South wing study · gym west + south, office east, the court in the middle · and an external stair at the south-east · Taif / Palm House V7.1

Owner's decisions 1 Nov 2026, APPLIED the same day (docs/PENDING_CHANGES.md): the swap with the suite court 2.5 m clear (y 19.25–21.9), the east enclosed stair tower continuing to the roof, the internal roof stair dropped; the pivoting TV panel NOT applied (it does not fit beside the office door in the 2.1 m shared wall: see the report) · this study keeps its original comparison · every size is a study assumption; the structure is a re-trace of the load paths, not a calculation (X5 stays open). **1 Nov 2026 after V8.0: the EXTERNAL STAIR TOWER IS REMOVED** (owner: cost and appearance): the roof by a maintenance ladder in the suite court (studies/roof.typ page 2), the office reached from the court only, visitors met in the men's majlis; §§ 7–11 and the tower in § 12 stay as the record.

CURRENT V7.1 · north up · 1 m = 0.74 cm

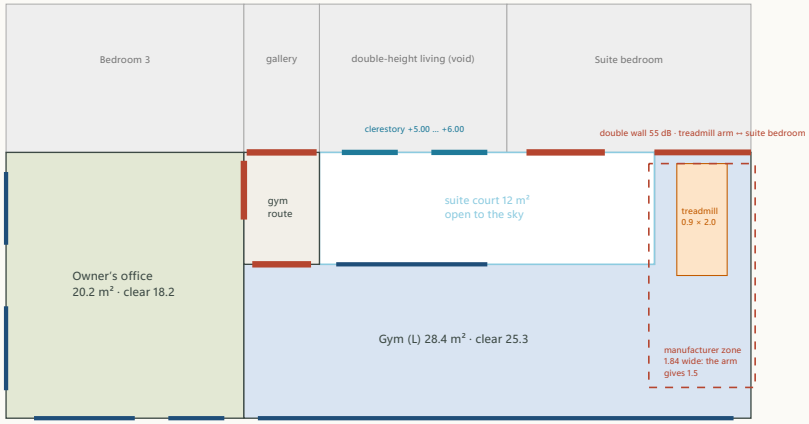
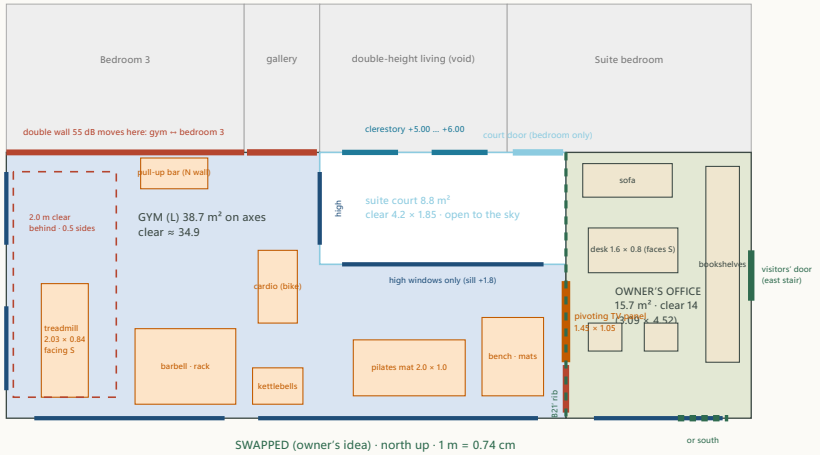
1 · The swapped wing: what it gives

- **Gym, an L:** the whole west part (x 0–5.6, 5.6 × 4.75 on axes) plus the south strip (x 5.6–10, 2.75 deep): **38.7 m² on axes, ≈ 34.9 m² clear** (today 28.4 / 25.3). Entered as today from the gallery end (x 4.3–5.55, y 19.25, sliding); windows west (two) and the south band x 0.5–9.5; onto the court **high-level windows only** (sill +1.8): the court stays private.

- **The treadmill fits with its manufacturer zone:** Life Fitness T5 class (assumed), 2.03 × 0.84 m, 2 m clear behind and 0.5 m each side (ASTM F2115 / the manual, assumed) → a zone 1.84 × 4.03 m; placed along the **west outer wall line** (the slab edge over the foyer's load-bearing west wall: the stiffest strip), facing south to the window band; it fits. Today's arm is 1.5 m clear: the owner's 0.3 m sides fit, the manufacturer's 1.84 m does not.

- **Suite court:** x 5.6–10, 2.0 deep: **8.8 m² on axes, 4.2 × 1.85 clear** (today 12 m²); enclosed on four sides: the living's clerestory wall and the suite bedroom north, the gym west (x 5.6) and south (y 21.25), the office east (x 10); reached from the suite bedroom only (a 0.9 m sliding door at x 9.05–9.95, the only part of the bedroom's south wall that touches the court). Its floor drain west as today.

- **Owner's office, east:** x 10–13.311 × 4.75: **15.7 m² on axes, 3.09 × 4.52 = 14 m² clear** (today 20.2 / 18.2): a desk facing the south window, a sofa on the suite wall, shelves east. Doors: from the gym's south strip (0.85, lockable from the office side) and the visitors' door to the external stair (east wall, or south). The office window south only (x 10.5–12.8); an east window only if the stair is not on the east.

SWAPPED (owner's idea) · north up · 1 m = 0.74 cm

2 · The pivoting TV panel in the shared gym / office wall (x 10, y 21.55–23)

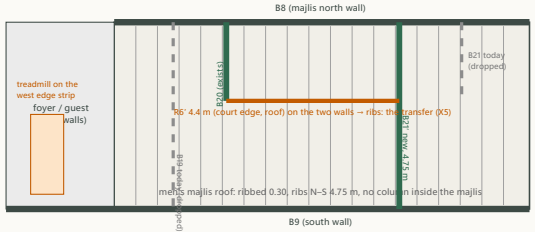
- **Opening:** 1.45 wide × 1.05 high (sill +0.95, head +2), 0.3 m south of R6's bearing on this wall, a lintel over it; the office door south of it (y 23.05–23.9).

- **Panel:** 0.18 m thick on a vertical centre pivot (the wall is 0.20: the panel's faces stand 0.01 proud each side, trimmed by a 15 mm stone architrave both sides). A welded steel frame, two 12.5 mm skins (fibre-cement or MDF), 100 mm mineral wool, a 55" TV (≈ 1.23 × 0.71) recessed flush in one face with a soundbar below it, the other face finished as the wall (or a second screen later). ≈ 75 kg incl. the TV; a floor pivot bearing + a top guide; cables through the hollow pivot post (slip ring or a service loop for 180°).

- **Sealed in both positions:** the panel turns 180° and fills the opening in either position; compression gaskets on all four edges are pressed by two cam locks (top / bottom) so there is no open gap — while turning, the half-width (0.72) swings into both rooms: keep 0.8 m free of furniture each side.

- **Expected sound reduction (assumed Rw):** the solid 200 mm plastered block wall ≈ 50 dB; the sealed panel ≈ 36 dB; the wall with the panel (1.52 m² in 9.63 m²) ≈ **43.2 dB**, i.e. 6.8 dB less than the solid wall; with worn gaskets (panel 30 dB) ≈ 37.8 dB. Enough between a gym and an office (normal speech inaudible, loud music audible); nothing like the 55 dB double wall a bedroom needs. The acoustic engineer confirms.

the men's majlis roof and the swapped walls · 1 m = 0.52 cm

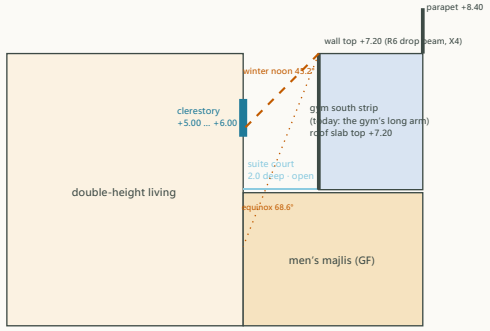
4 · The load paths of the swapped wing

Wall	Stands on	Change
x 5.6, y 19.25–21.25 (gym west ↔ court)	thickened rib **B20** (exists today under the same wall)	as today
x 10.0, y 19.25–24.0 (court ↔ office, gym ↔ office)	a thickened rib **B21′** on x 10.0 for the full 4.75 m (today B21 sits on x 11.586 over 2.0 m): parallel to the ribs, direct and cheap	moved rib
y 21.25, x 5.6–10.0 (court ↔ gym south strip)	crosses the ribs, 4.4 m, nothing below: a **light partition** (100 mm, high windows) as recommended today for the 7.7 m gym north wall	partition
y 19.25, x 0–13.311 (bedroom 3 / living / suite bedroom south walls)	beam **B8** on the men's majlis north wall	as today
x 0, y 24, x 13.311	outer walls on the ground-floor outer walls (foyer west wall, majlis south and east walls)	as today
x 4.25 (today's office / gym route wall on B19)	no wall any more: B19 not needed, or kept as a stiffening rib under the treadmill if the treadmill moves to x 4.25	dropped

- **Roof over the wing:** the gym's west part (x 0–5.6, 4.75 span) ribbed 0.30 N–S like today's office roof; the south strip (2.75 span) solid 0.20 as today; the office (3.3 wide) solid 0.20 spanning **east–west** between the x 10 wall and the east outer wall. **R6′**, the court's south roof edge, shrinks from 6.0 to 4.4 m (≈ −27 % load) but is still a wall-on-rib transfer: **X5 is lighter, not closed.**

- **The engineer must confirm:** the ribs B20 / B21′ carrying the walls and R6′ (sizes, deflection); the majlis roof's vibration under the treadmill (home gym live load, SBC 301); the lintel over the pivot opening; the roof option; the east outer wall taking the office roof.

site plan (base.typ frame: origin M1, y along the M line) · 1 m = 0.33 cm · true north 21.4° off the page's up

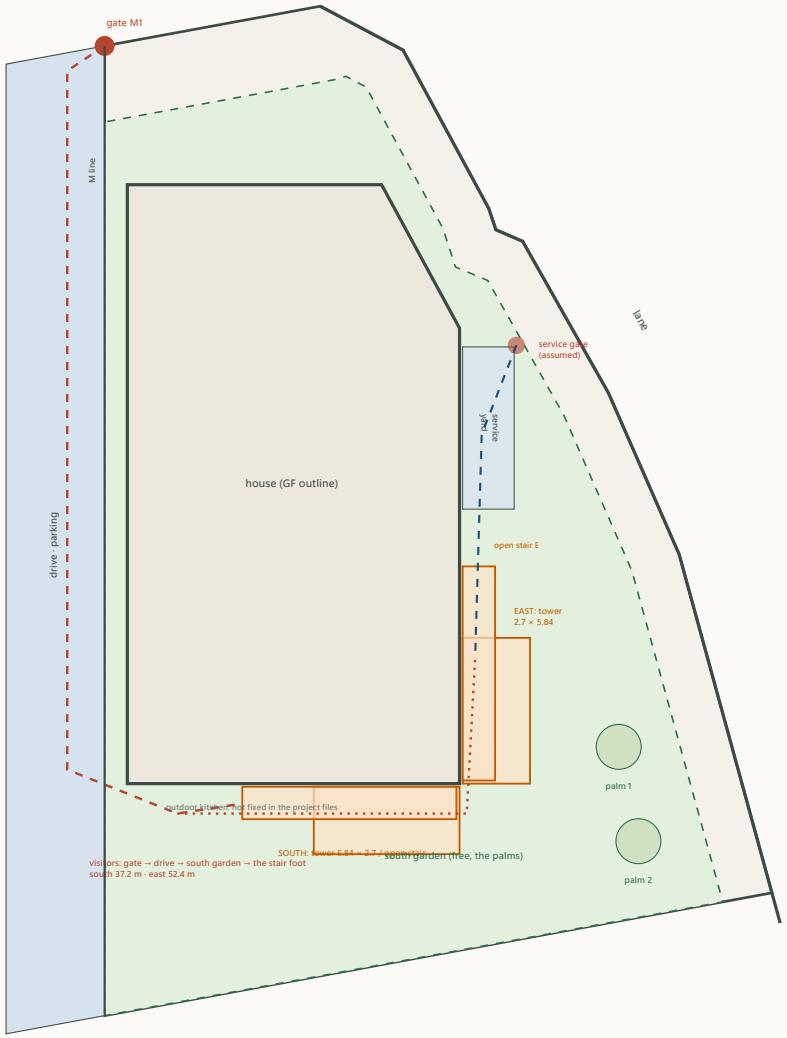
- **Route from the site gate (M1, north-west):** visitors walk down the drive on the west (where the cars park), round the south-west corner past the guest foyer, and along the south garden: ≈ 37.2 m to a south stair, ≈ 52.4 m round the corner to an east stair. They never enter the house. **Workers** come best through a **service gate on the lane** (assumed near the east yard, not yet in the project files): ≈ 12.8 m along the east side to an east stair, past the service yard (rubbish, deliveries, gas) and well clear of the courtyard windows.

- **Relations:** the **east** stair sits on the service side, next to the yard and the lane: workers' side, the south garden and the palms untouched; the **south** stair sits on the garden side, closer to the drive / parking (≈ 5 m shorter walk) but it crosses the men's majlis south facade in front of its high windows (sill +1.8 at the ground floor: a stair user looks straight in) and takes the garden strip where the **outdoor kitchen** would go (its position is not fixed in the project files).

- **The office's door:** on the east wall (y 21.0–21.9) for an east stair, on the south wall (x 12.0–12.9) for a south stair.

SOUTH elevation (seen from the garden), form (a) on the south · 1 m = 0.42 cm · ground −0.30

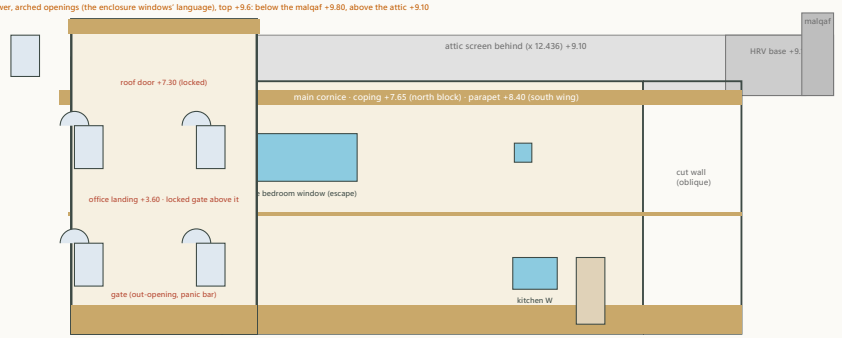
- **(a) the open stone stair** reads as a garden stair of the Hejaz houses: honest, light, cheap; but it draws a long diagonal across a facade whose language is horizontal (the band, the cornice, the parapet) and it can only reach the office landing (a second run to the roof stacked over it has no headroom). On the south it crosses the men's majlis windows; on the east it runs under the suite bedroom's escape window. **It looks added on unless it is short and tucked into the corner.**

- **(b) the enclosed tower** with two arched openings per storey in the enclosure windows' language, a stone plinth and the main cornice line carried round it, top +9.6: a designed mass. On the **east** it pairs with the malqaf tower (+9.80) at the other end of the lane facade: two vertical elements on the service side, the attic screen between them, the garden facade untouched. On the **south** it would stand alone in the middle of the quiet garden front. **The east tower looks designed; it works best if it also replaces the internal roof stair (§ 9), so the stair room at the north-west disappears and the roofline keeps exactly two verticals.**
